**Kawasaki BK117**

TITLE: Upgrade to Underwater Locater Beacon (ULB) of Data Acquisition Flight Recorder (DAFR)

DATA ACQUISITION FLIGHT RECORDER (DAFR) TYPE D51615-202-XXX AND DUAL INPUT DATA ACQUISITION FLIGHT RECORDER (DIDAFR) TYPE D51615-203-XXX REPLACEMENT UNDERWATER LOCATOR BEACON (90-DAY) UPGRADE KIT P/N KIT112814

DOCUMENT No.: SB D51615-31-19
DATE OF ISSUE: 29th June 2017
REVISION: Revision 10
DATE OF REVISION: 17th November 2021
CLASSIFICATION: INFORMATION

Figure 1 Existing 30-Day Beacon Mounting and Label layout

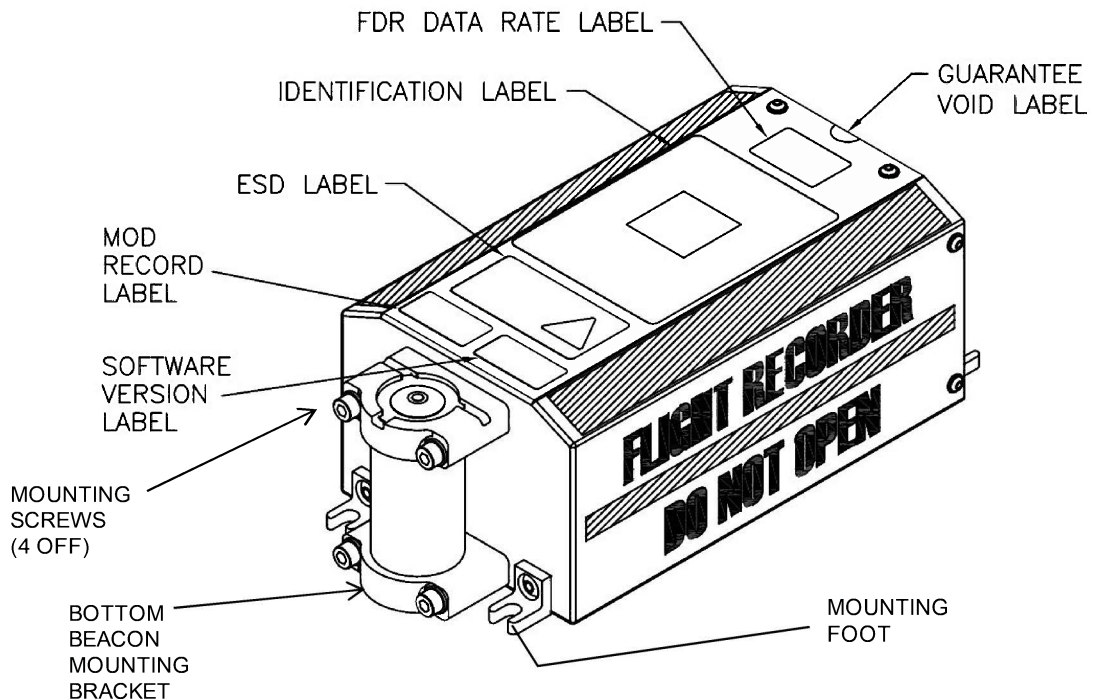
3.2.1 Removal of the Existing ULB

- (1) Remove and retain the four screws and washers which secure the recorder to the aircraft structure
- (2) Remove the recorder from the Aircraft
- (3) Remove and discard the four existing mounting screws (P/N 435890007) which secure the current ULB top and bottom mounting brackets

- (4) Remove and discard the existing ULB and mounting bracket assembly
- (5) Remove and discard the two screws and washers (P/N 435890001 & 680150161) which secure the two mounting foot assemblies (P/N SA111463) (ULB end) to the recorder external casing

- (6) Remove and discard the two mounting foot assemblies
- (7) Using a scalpel or craft knife (Table 3, Item 7), gently lift one corner of the following labels:

Figure 2 Identification Label Placement

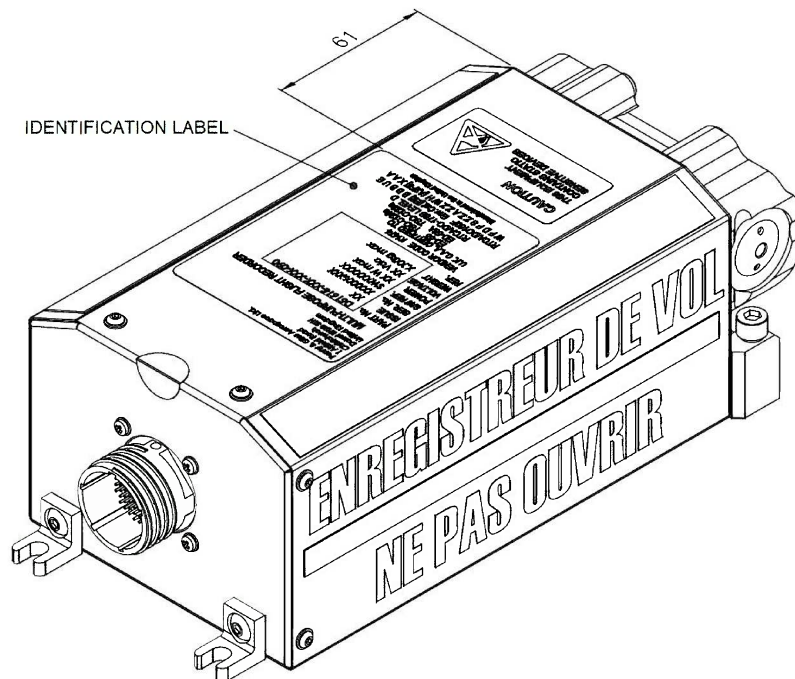
3.2.3 Fitting the 90-Day ULB Upgrade Kit p/n: KIT112814

- (1) Using screws (60) and washers (50), fit Retaining Feet & Roll Pin assemblies into position on the rear face of the Recorder unit
- (2) Apply Loctite 222 to the threads and torque tighten screws to 3.9 - 4.3Nm

- (3) Secure the RH bracket assembly (10) to the recorder using one of the longer fixing screws (110) and washers (50) in the upper location
- (4) Secure the RH bracket assembly to the recorder using one of the shorter fixing screws (90) and washers (50) in the lower location

- (6) Fit the fluorosilicone seal (140) into the bore of the appropriate mounting bracket into which the base of the beacon (130) is to be located (refer to Figure 2)
- (7) Slide the ULB into the bracket firmly up against the seal
- (8) Secure LH bracket (120) to the recorder using screws (90), (110) and washers (50). See steps 3 & 4 above

Carefully apply the new identification label (supplied as part of the 90-Day ULB Upgrade Kit) to the top surface of the Main Cover centrally, approximately 61mm from the bottom edge of the Main Cover (see *Figure 2*). Ensure the identification label is securely fitted.

Figure 3 MOD Record Label Placement

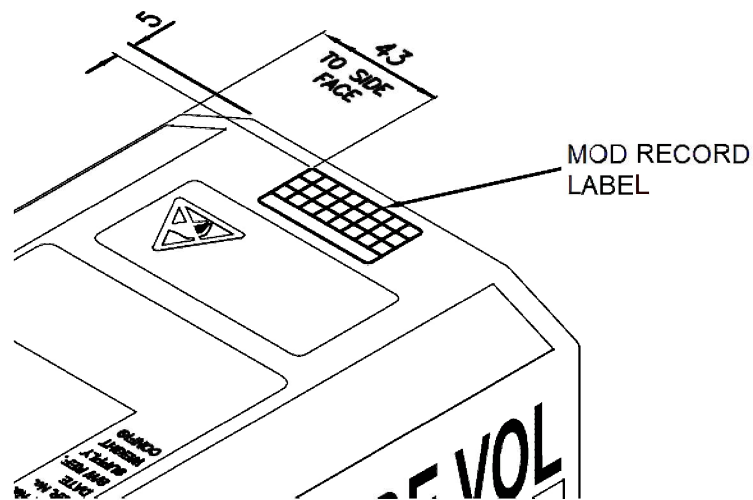
Carefully apply the Modification label centrally below the ESD label, approximately 5mm from the bottom edge and 43mm from the side face of the Main Cover (see *Figure 3*).

Figure 4 90-Day Beacon Mounting and Label Arrangement

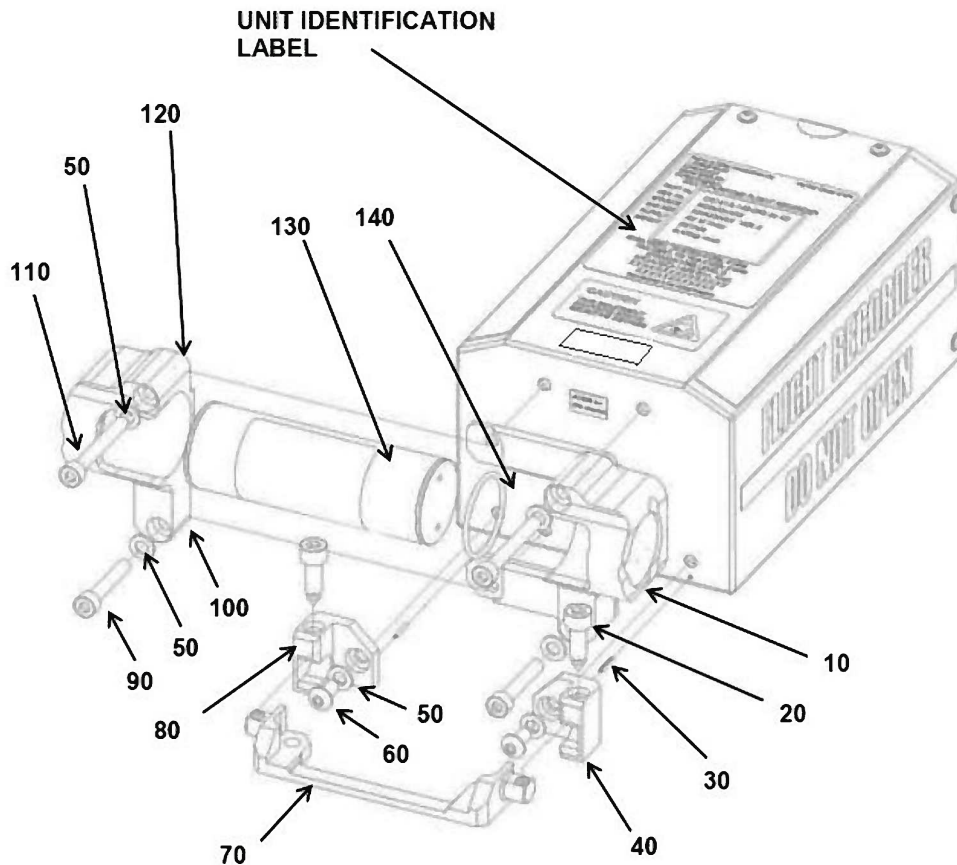
The new 90-day ULB is approximately 1 inch (25mm) longer than the existing 30-day ULB currently in use. As a result, the mounting brackets which secure the ULB to the recorder have been re-designed and the ULB mounting arrangement has been rotated by 90 degrees to fit the existing size envelope of the recorder unit and ULB combined.

- The two existing mounting feet attached to the recorder outer casing have been replaced by two (handed) foot fittings attached to the recorder rear casing using the existing screw locations.
- The recorder is secured to the aircraft structure with a retention plate which is mounted on the aircraft structure and secured to the two new foot fittings on the rear of the recorder by two cap-head screws.

- (1) Fit the retention plate (70) to the aircraft structure using two of the cap-head screws (6.35mm Dia.) and washers removed in *Section 3.2.1, Step (1)*
- (2) Locate the foot retention fittings (40) and (80) into the retention plate (70)
- (3) Apply a small amount of Loctite 222 to the threads of the screws (20)
- (4) Secure the Retention assembly with the two screws (20) and torque tighten the screws to between 4.5 and 5.0Nm
- (5) Secure the two existing recorder foot fittings to the aircraft structure using the remaining two cap head screws and washers removed in *Section 3.2.1, Step (1)*
